**Addendum No.:** 1

**City Project:** 19-33, "Dried Solids Storage Area"

**ADDENDUM NO. 1**

**City of Turlock  
Contract Documents and Construction Specifications  
Project No: 19-33  
Dried Solids Laydown Area**

DRAWING NO. SD-3  
COUNCIL APPROVAL NOV., 2015

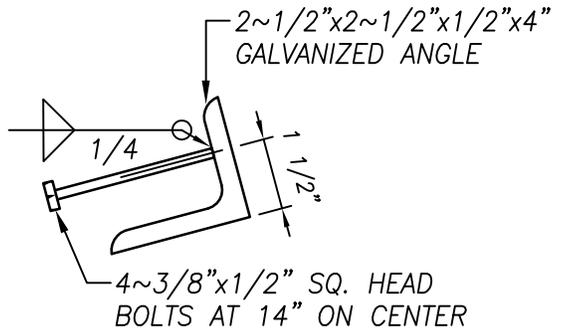
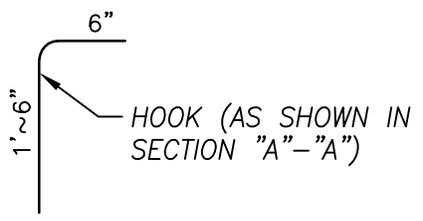
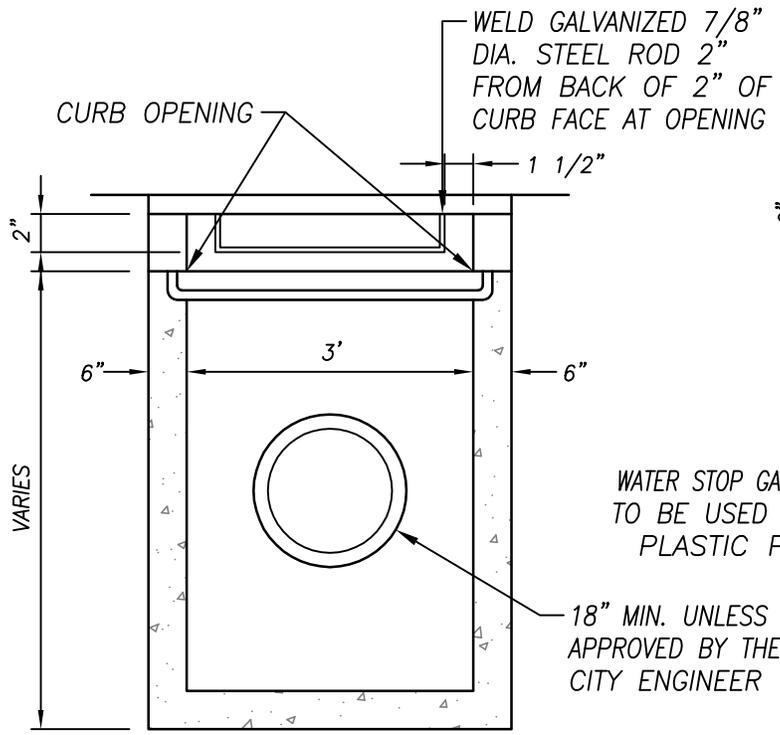
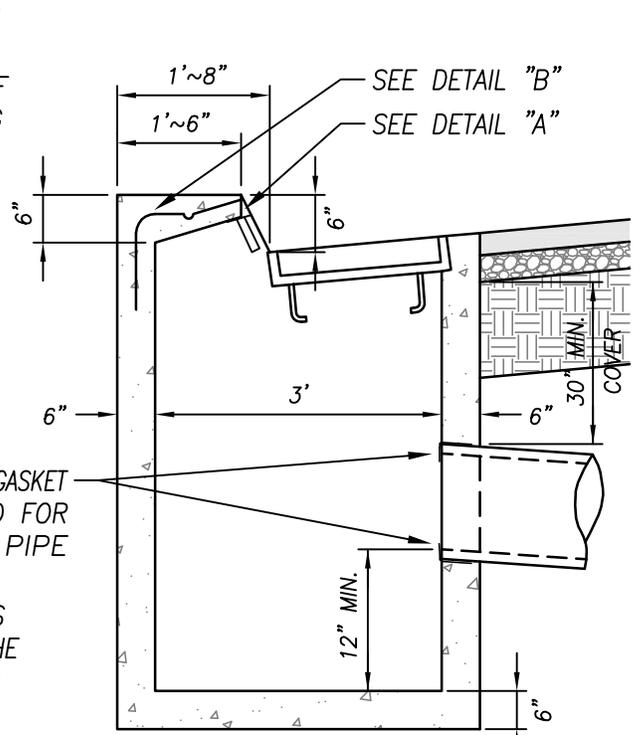
4. Please provide the City of Turlock Standard Detail SD-3 for the catch basin shown on Drawing C-101.

Answer: Attached.

**SHEET NUMBER**  
 G-101

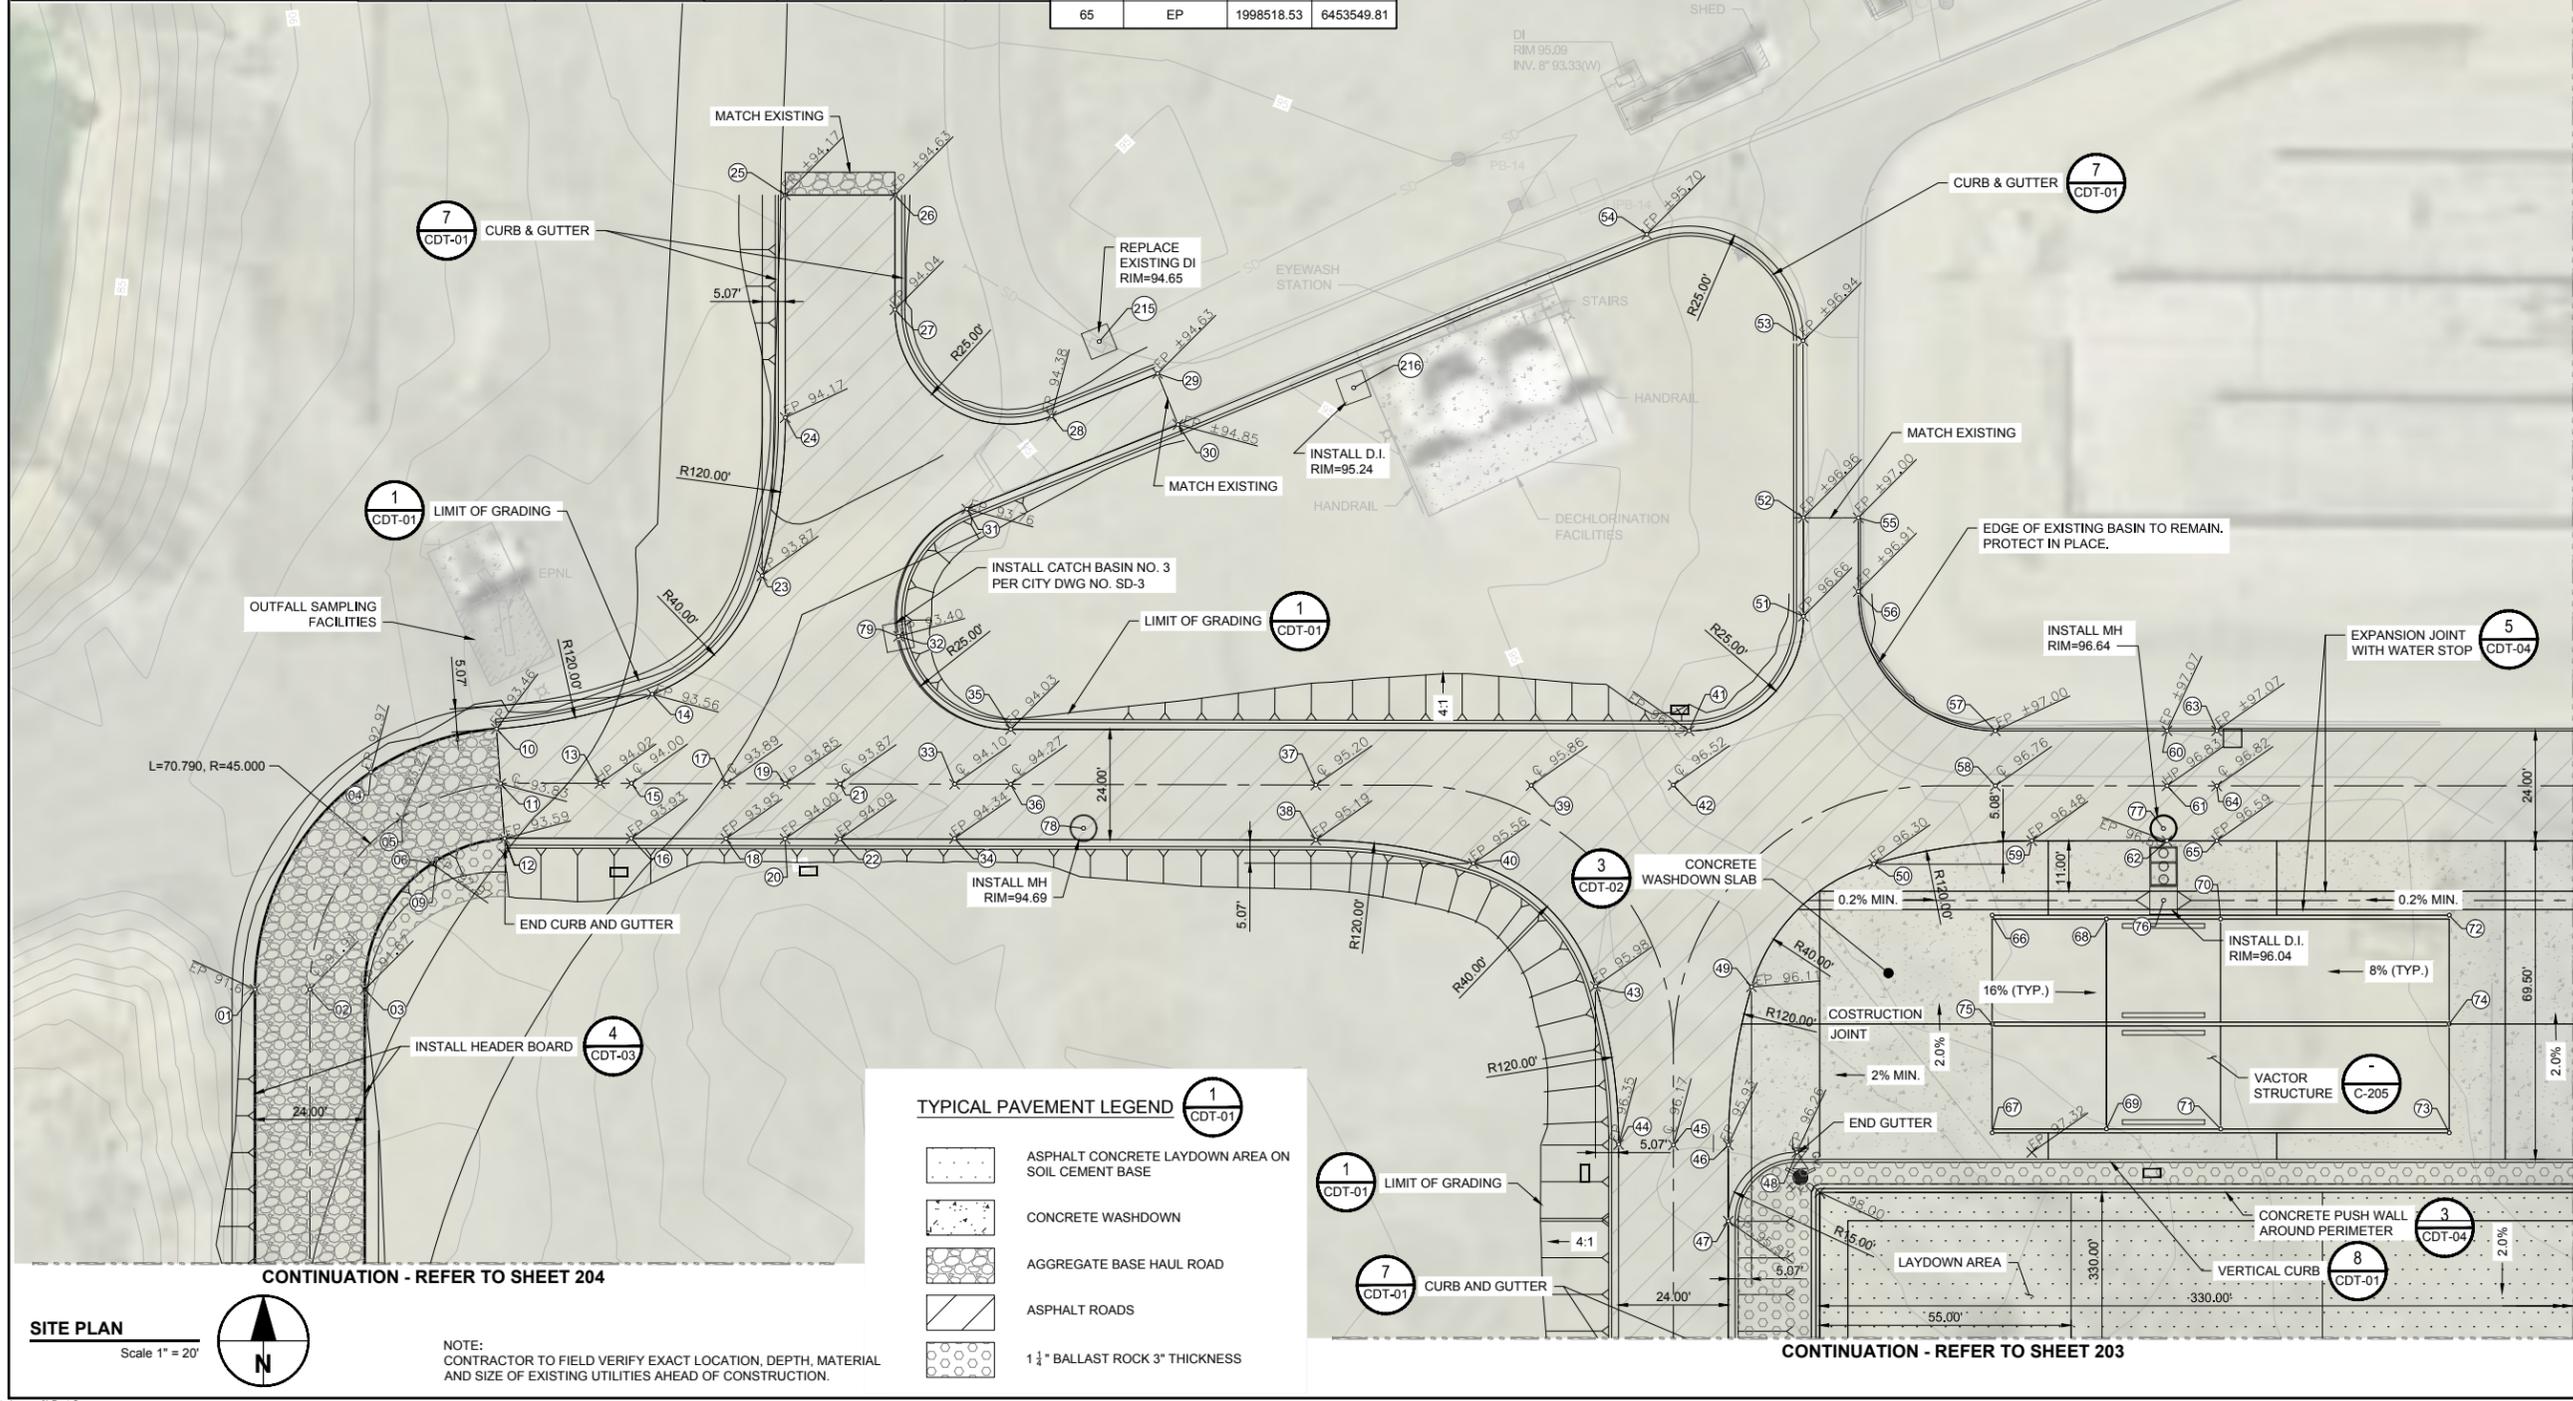
11.	Drawing G-101	Added a designated Staging Area to the west and south of the Laydown Area for staging equipment and stockpiling materials. Updated sheet attached.

**PROJECT NUMBER**  
60563672  
**SHEET TITLE**  
GRADING PLAN  
**SHEET NUMBER**  
C-201

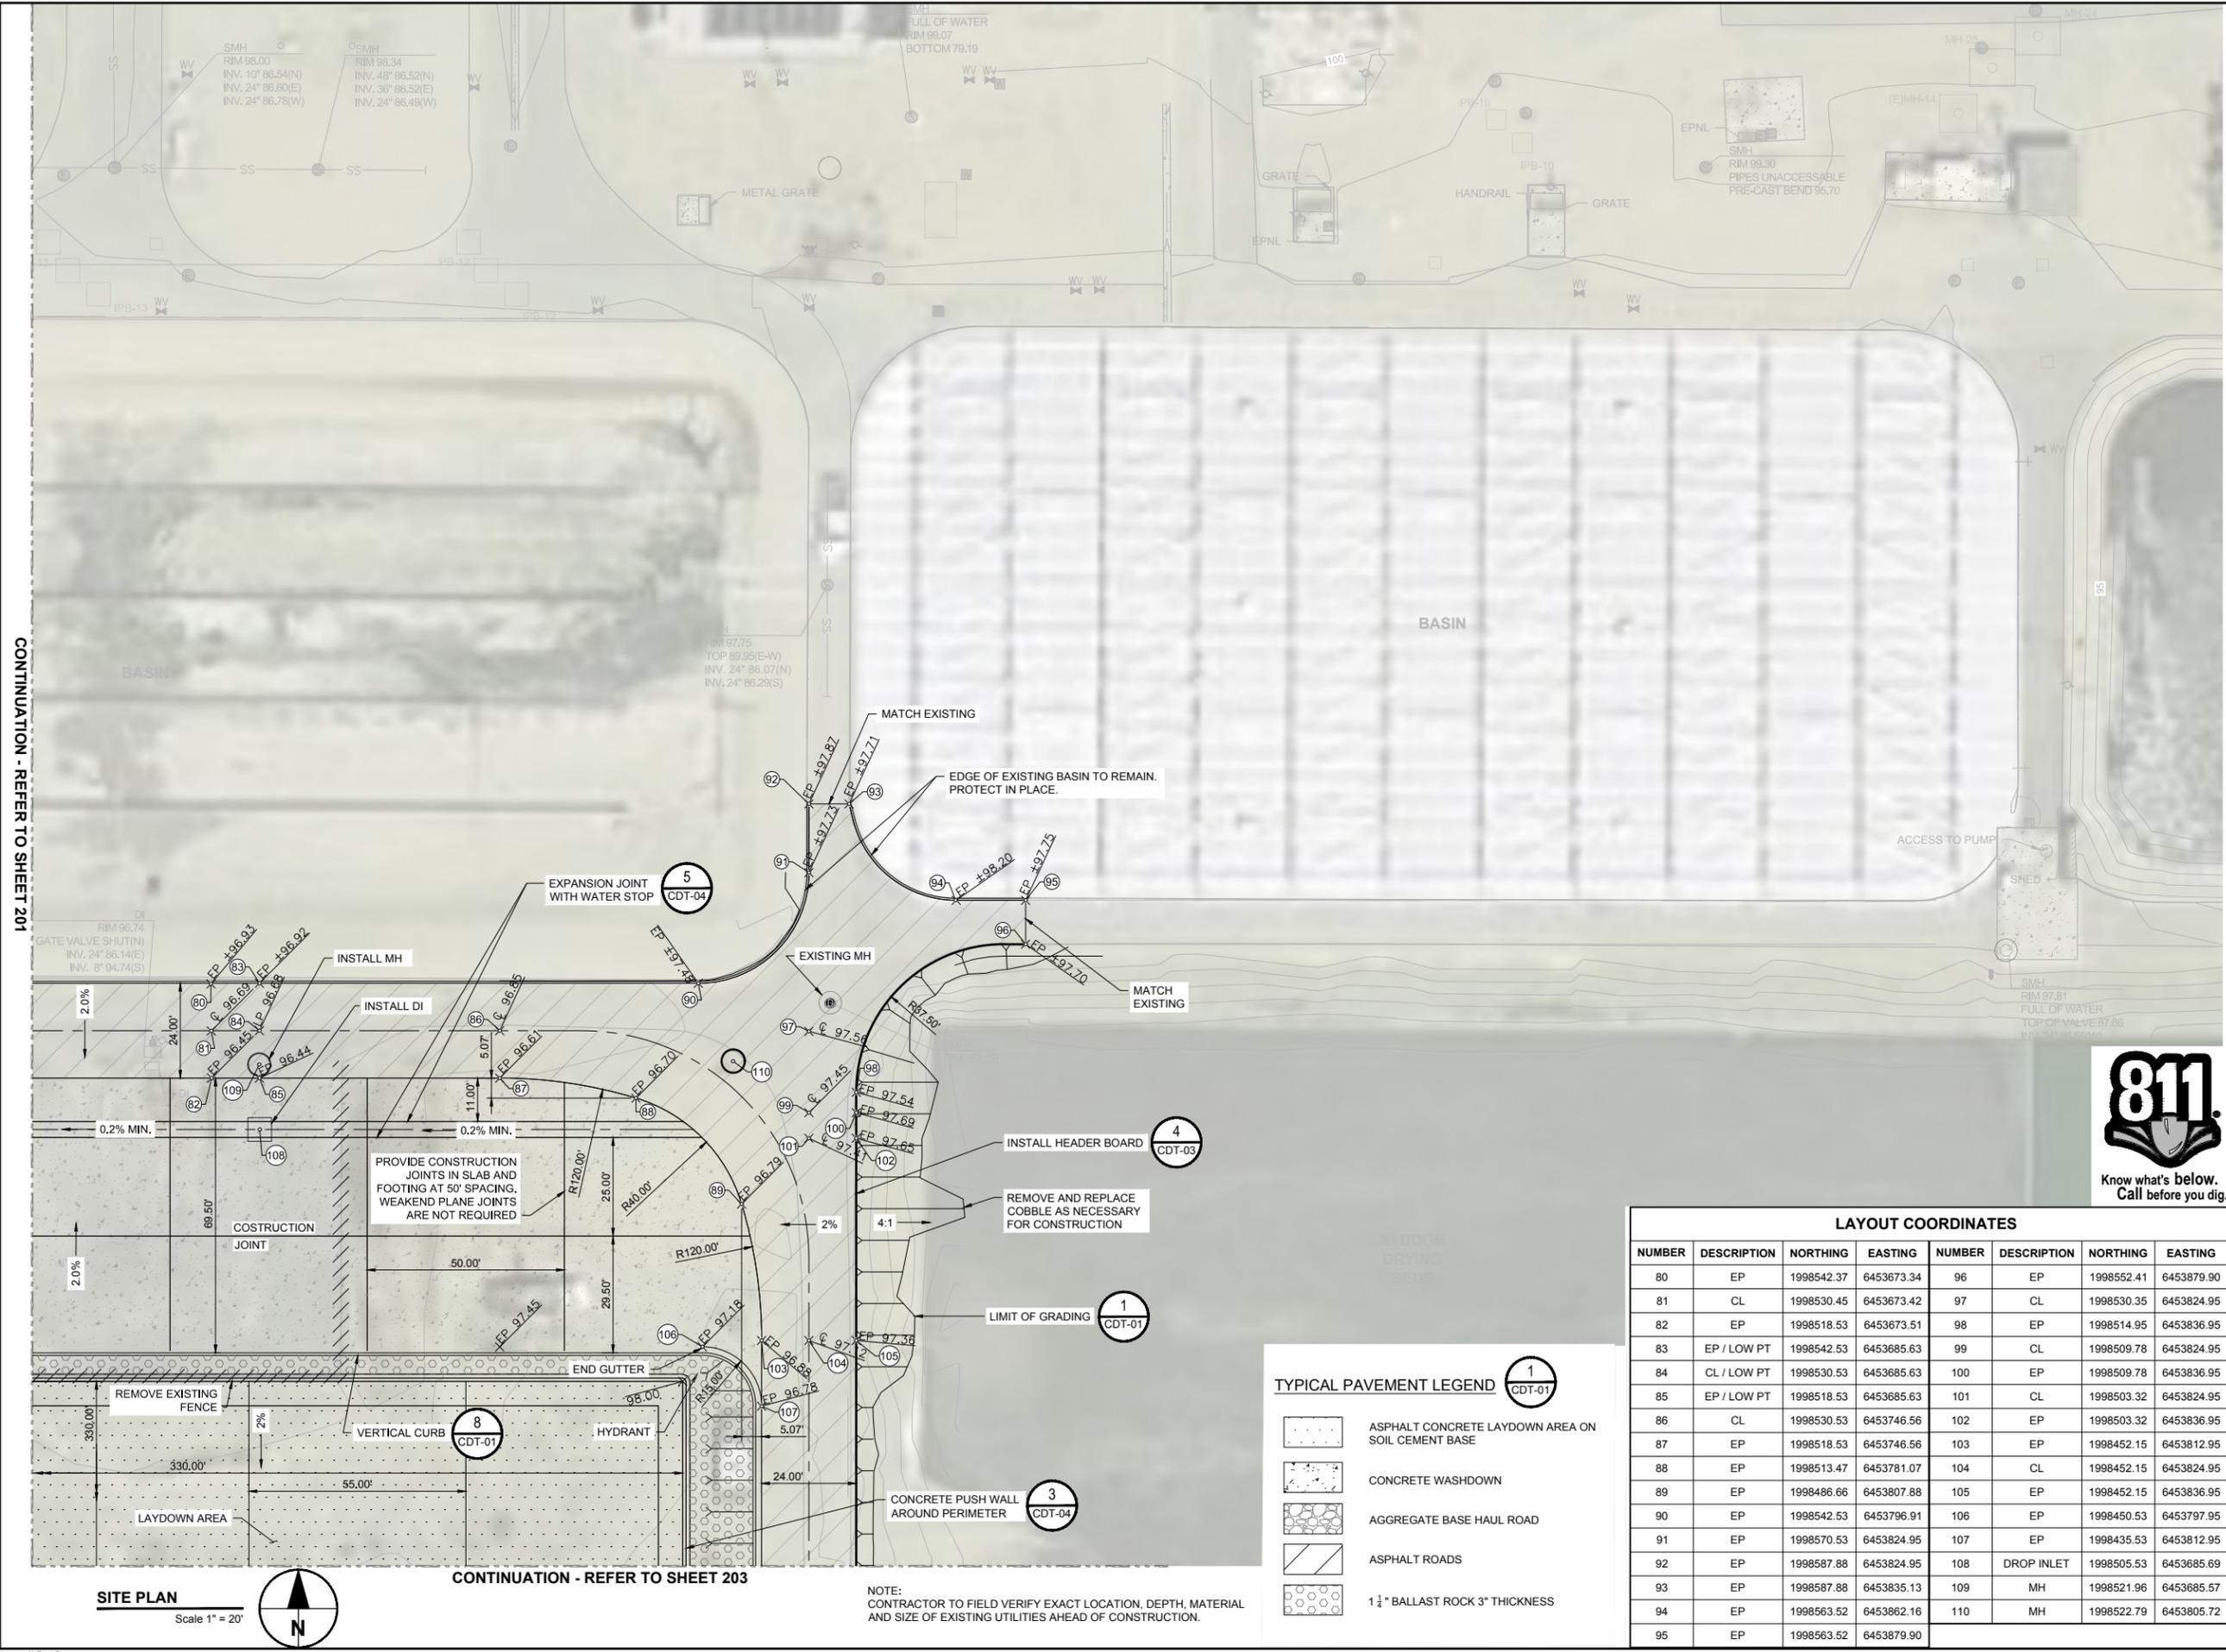
12.	Drawings C-201 through C-205	Linework labeled "Install Header Board 4/C-503" has been adjusted to double thickness to clarify the extent of header board installation required under Bid Item 22.  Construction joint layout in washdown area has been modified to be consistent between sheets.  Gutter has been removed along the north side of the washdown area.  Corrected concrete push wall detail reference to 3/CDT-04  Updated sheet attached.

13. Drawings C-201, C-202 and C-205 indicate curb and gutter between the ballast rock north of the laydown area push wall and the concrete washdown. The concrete washdown slopes to the north away from the curb and gutter. Please clarify configuration of the curb and gutter at this location.

Answer: Sheets C-201, C-202 and C-205 have been revised to omit the gutter in this section.
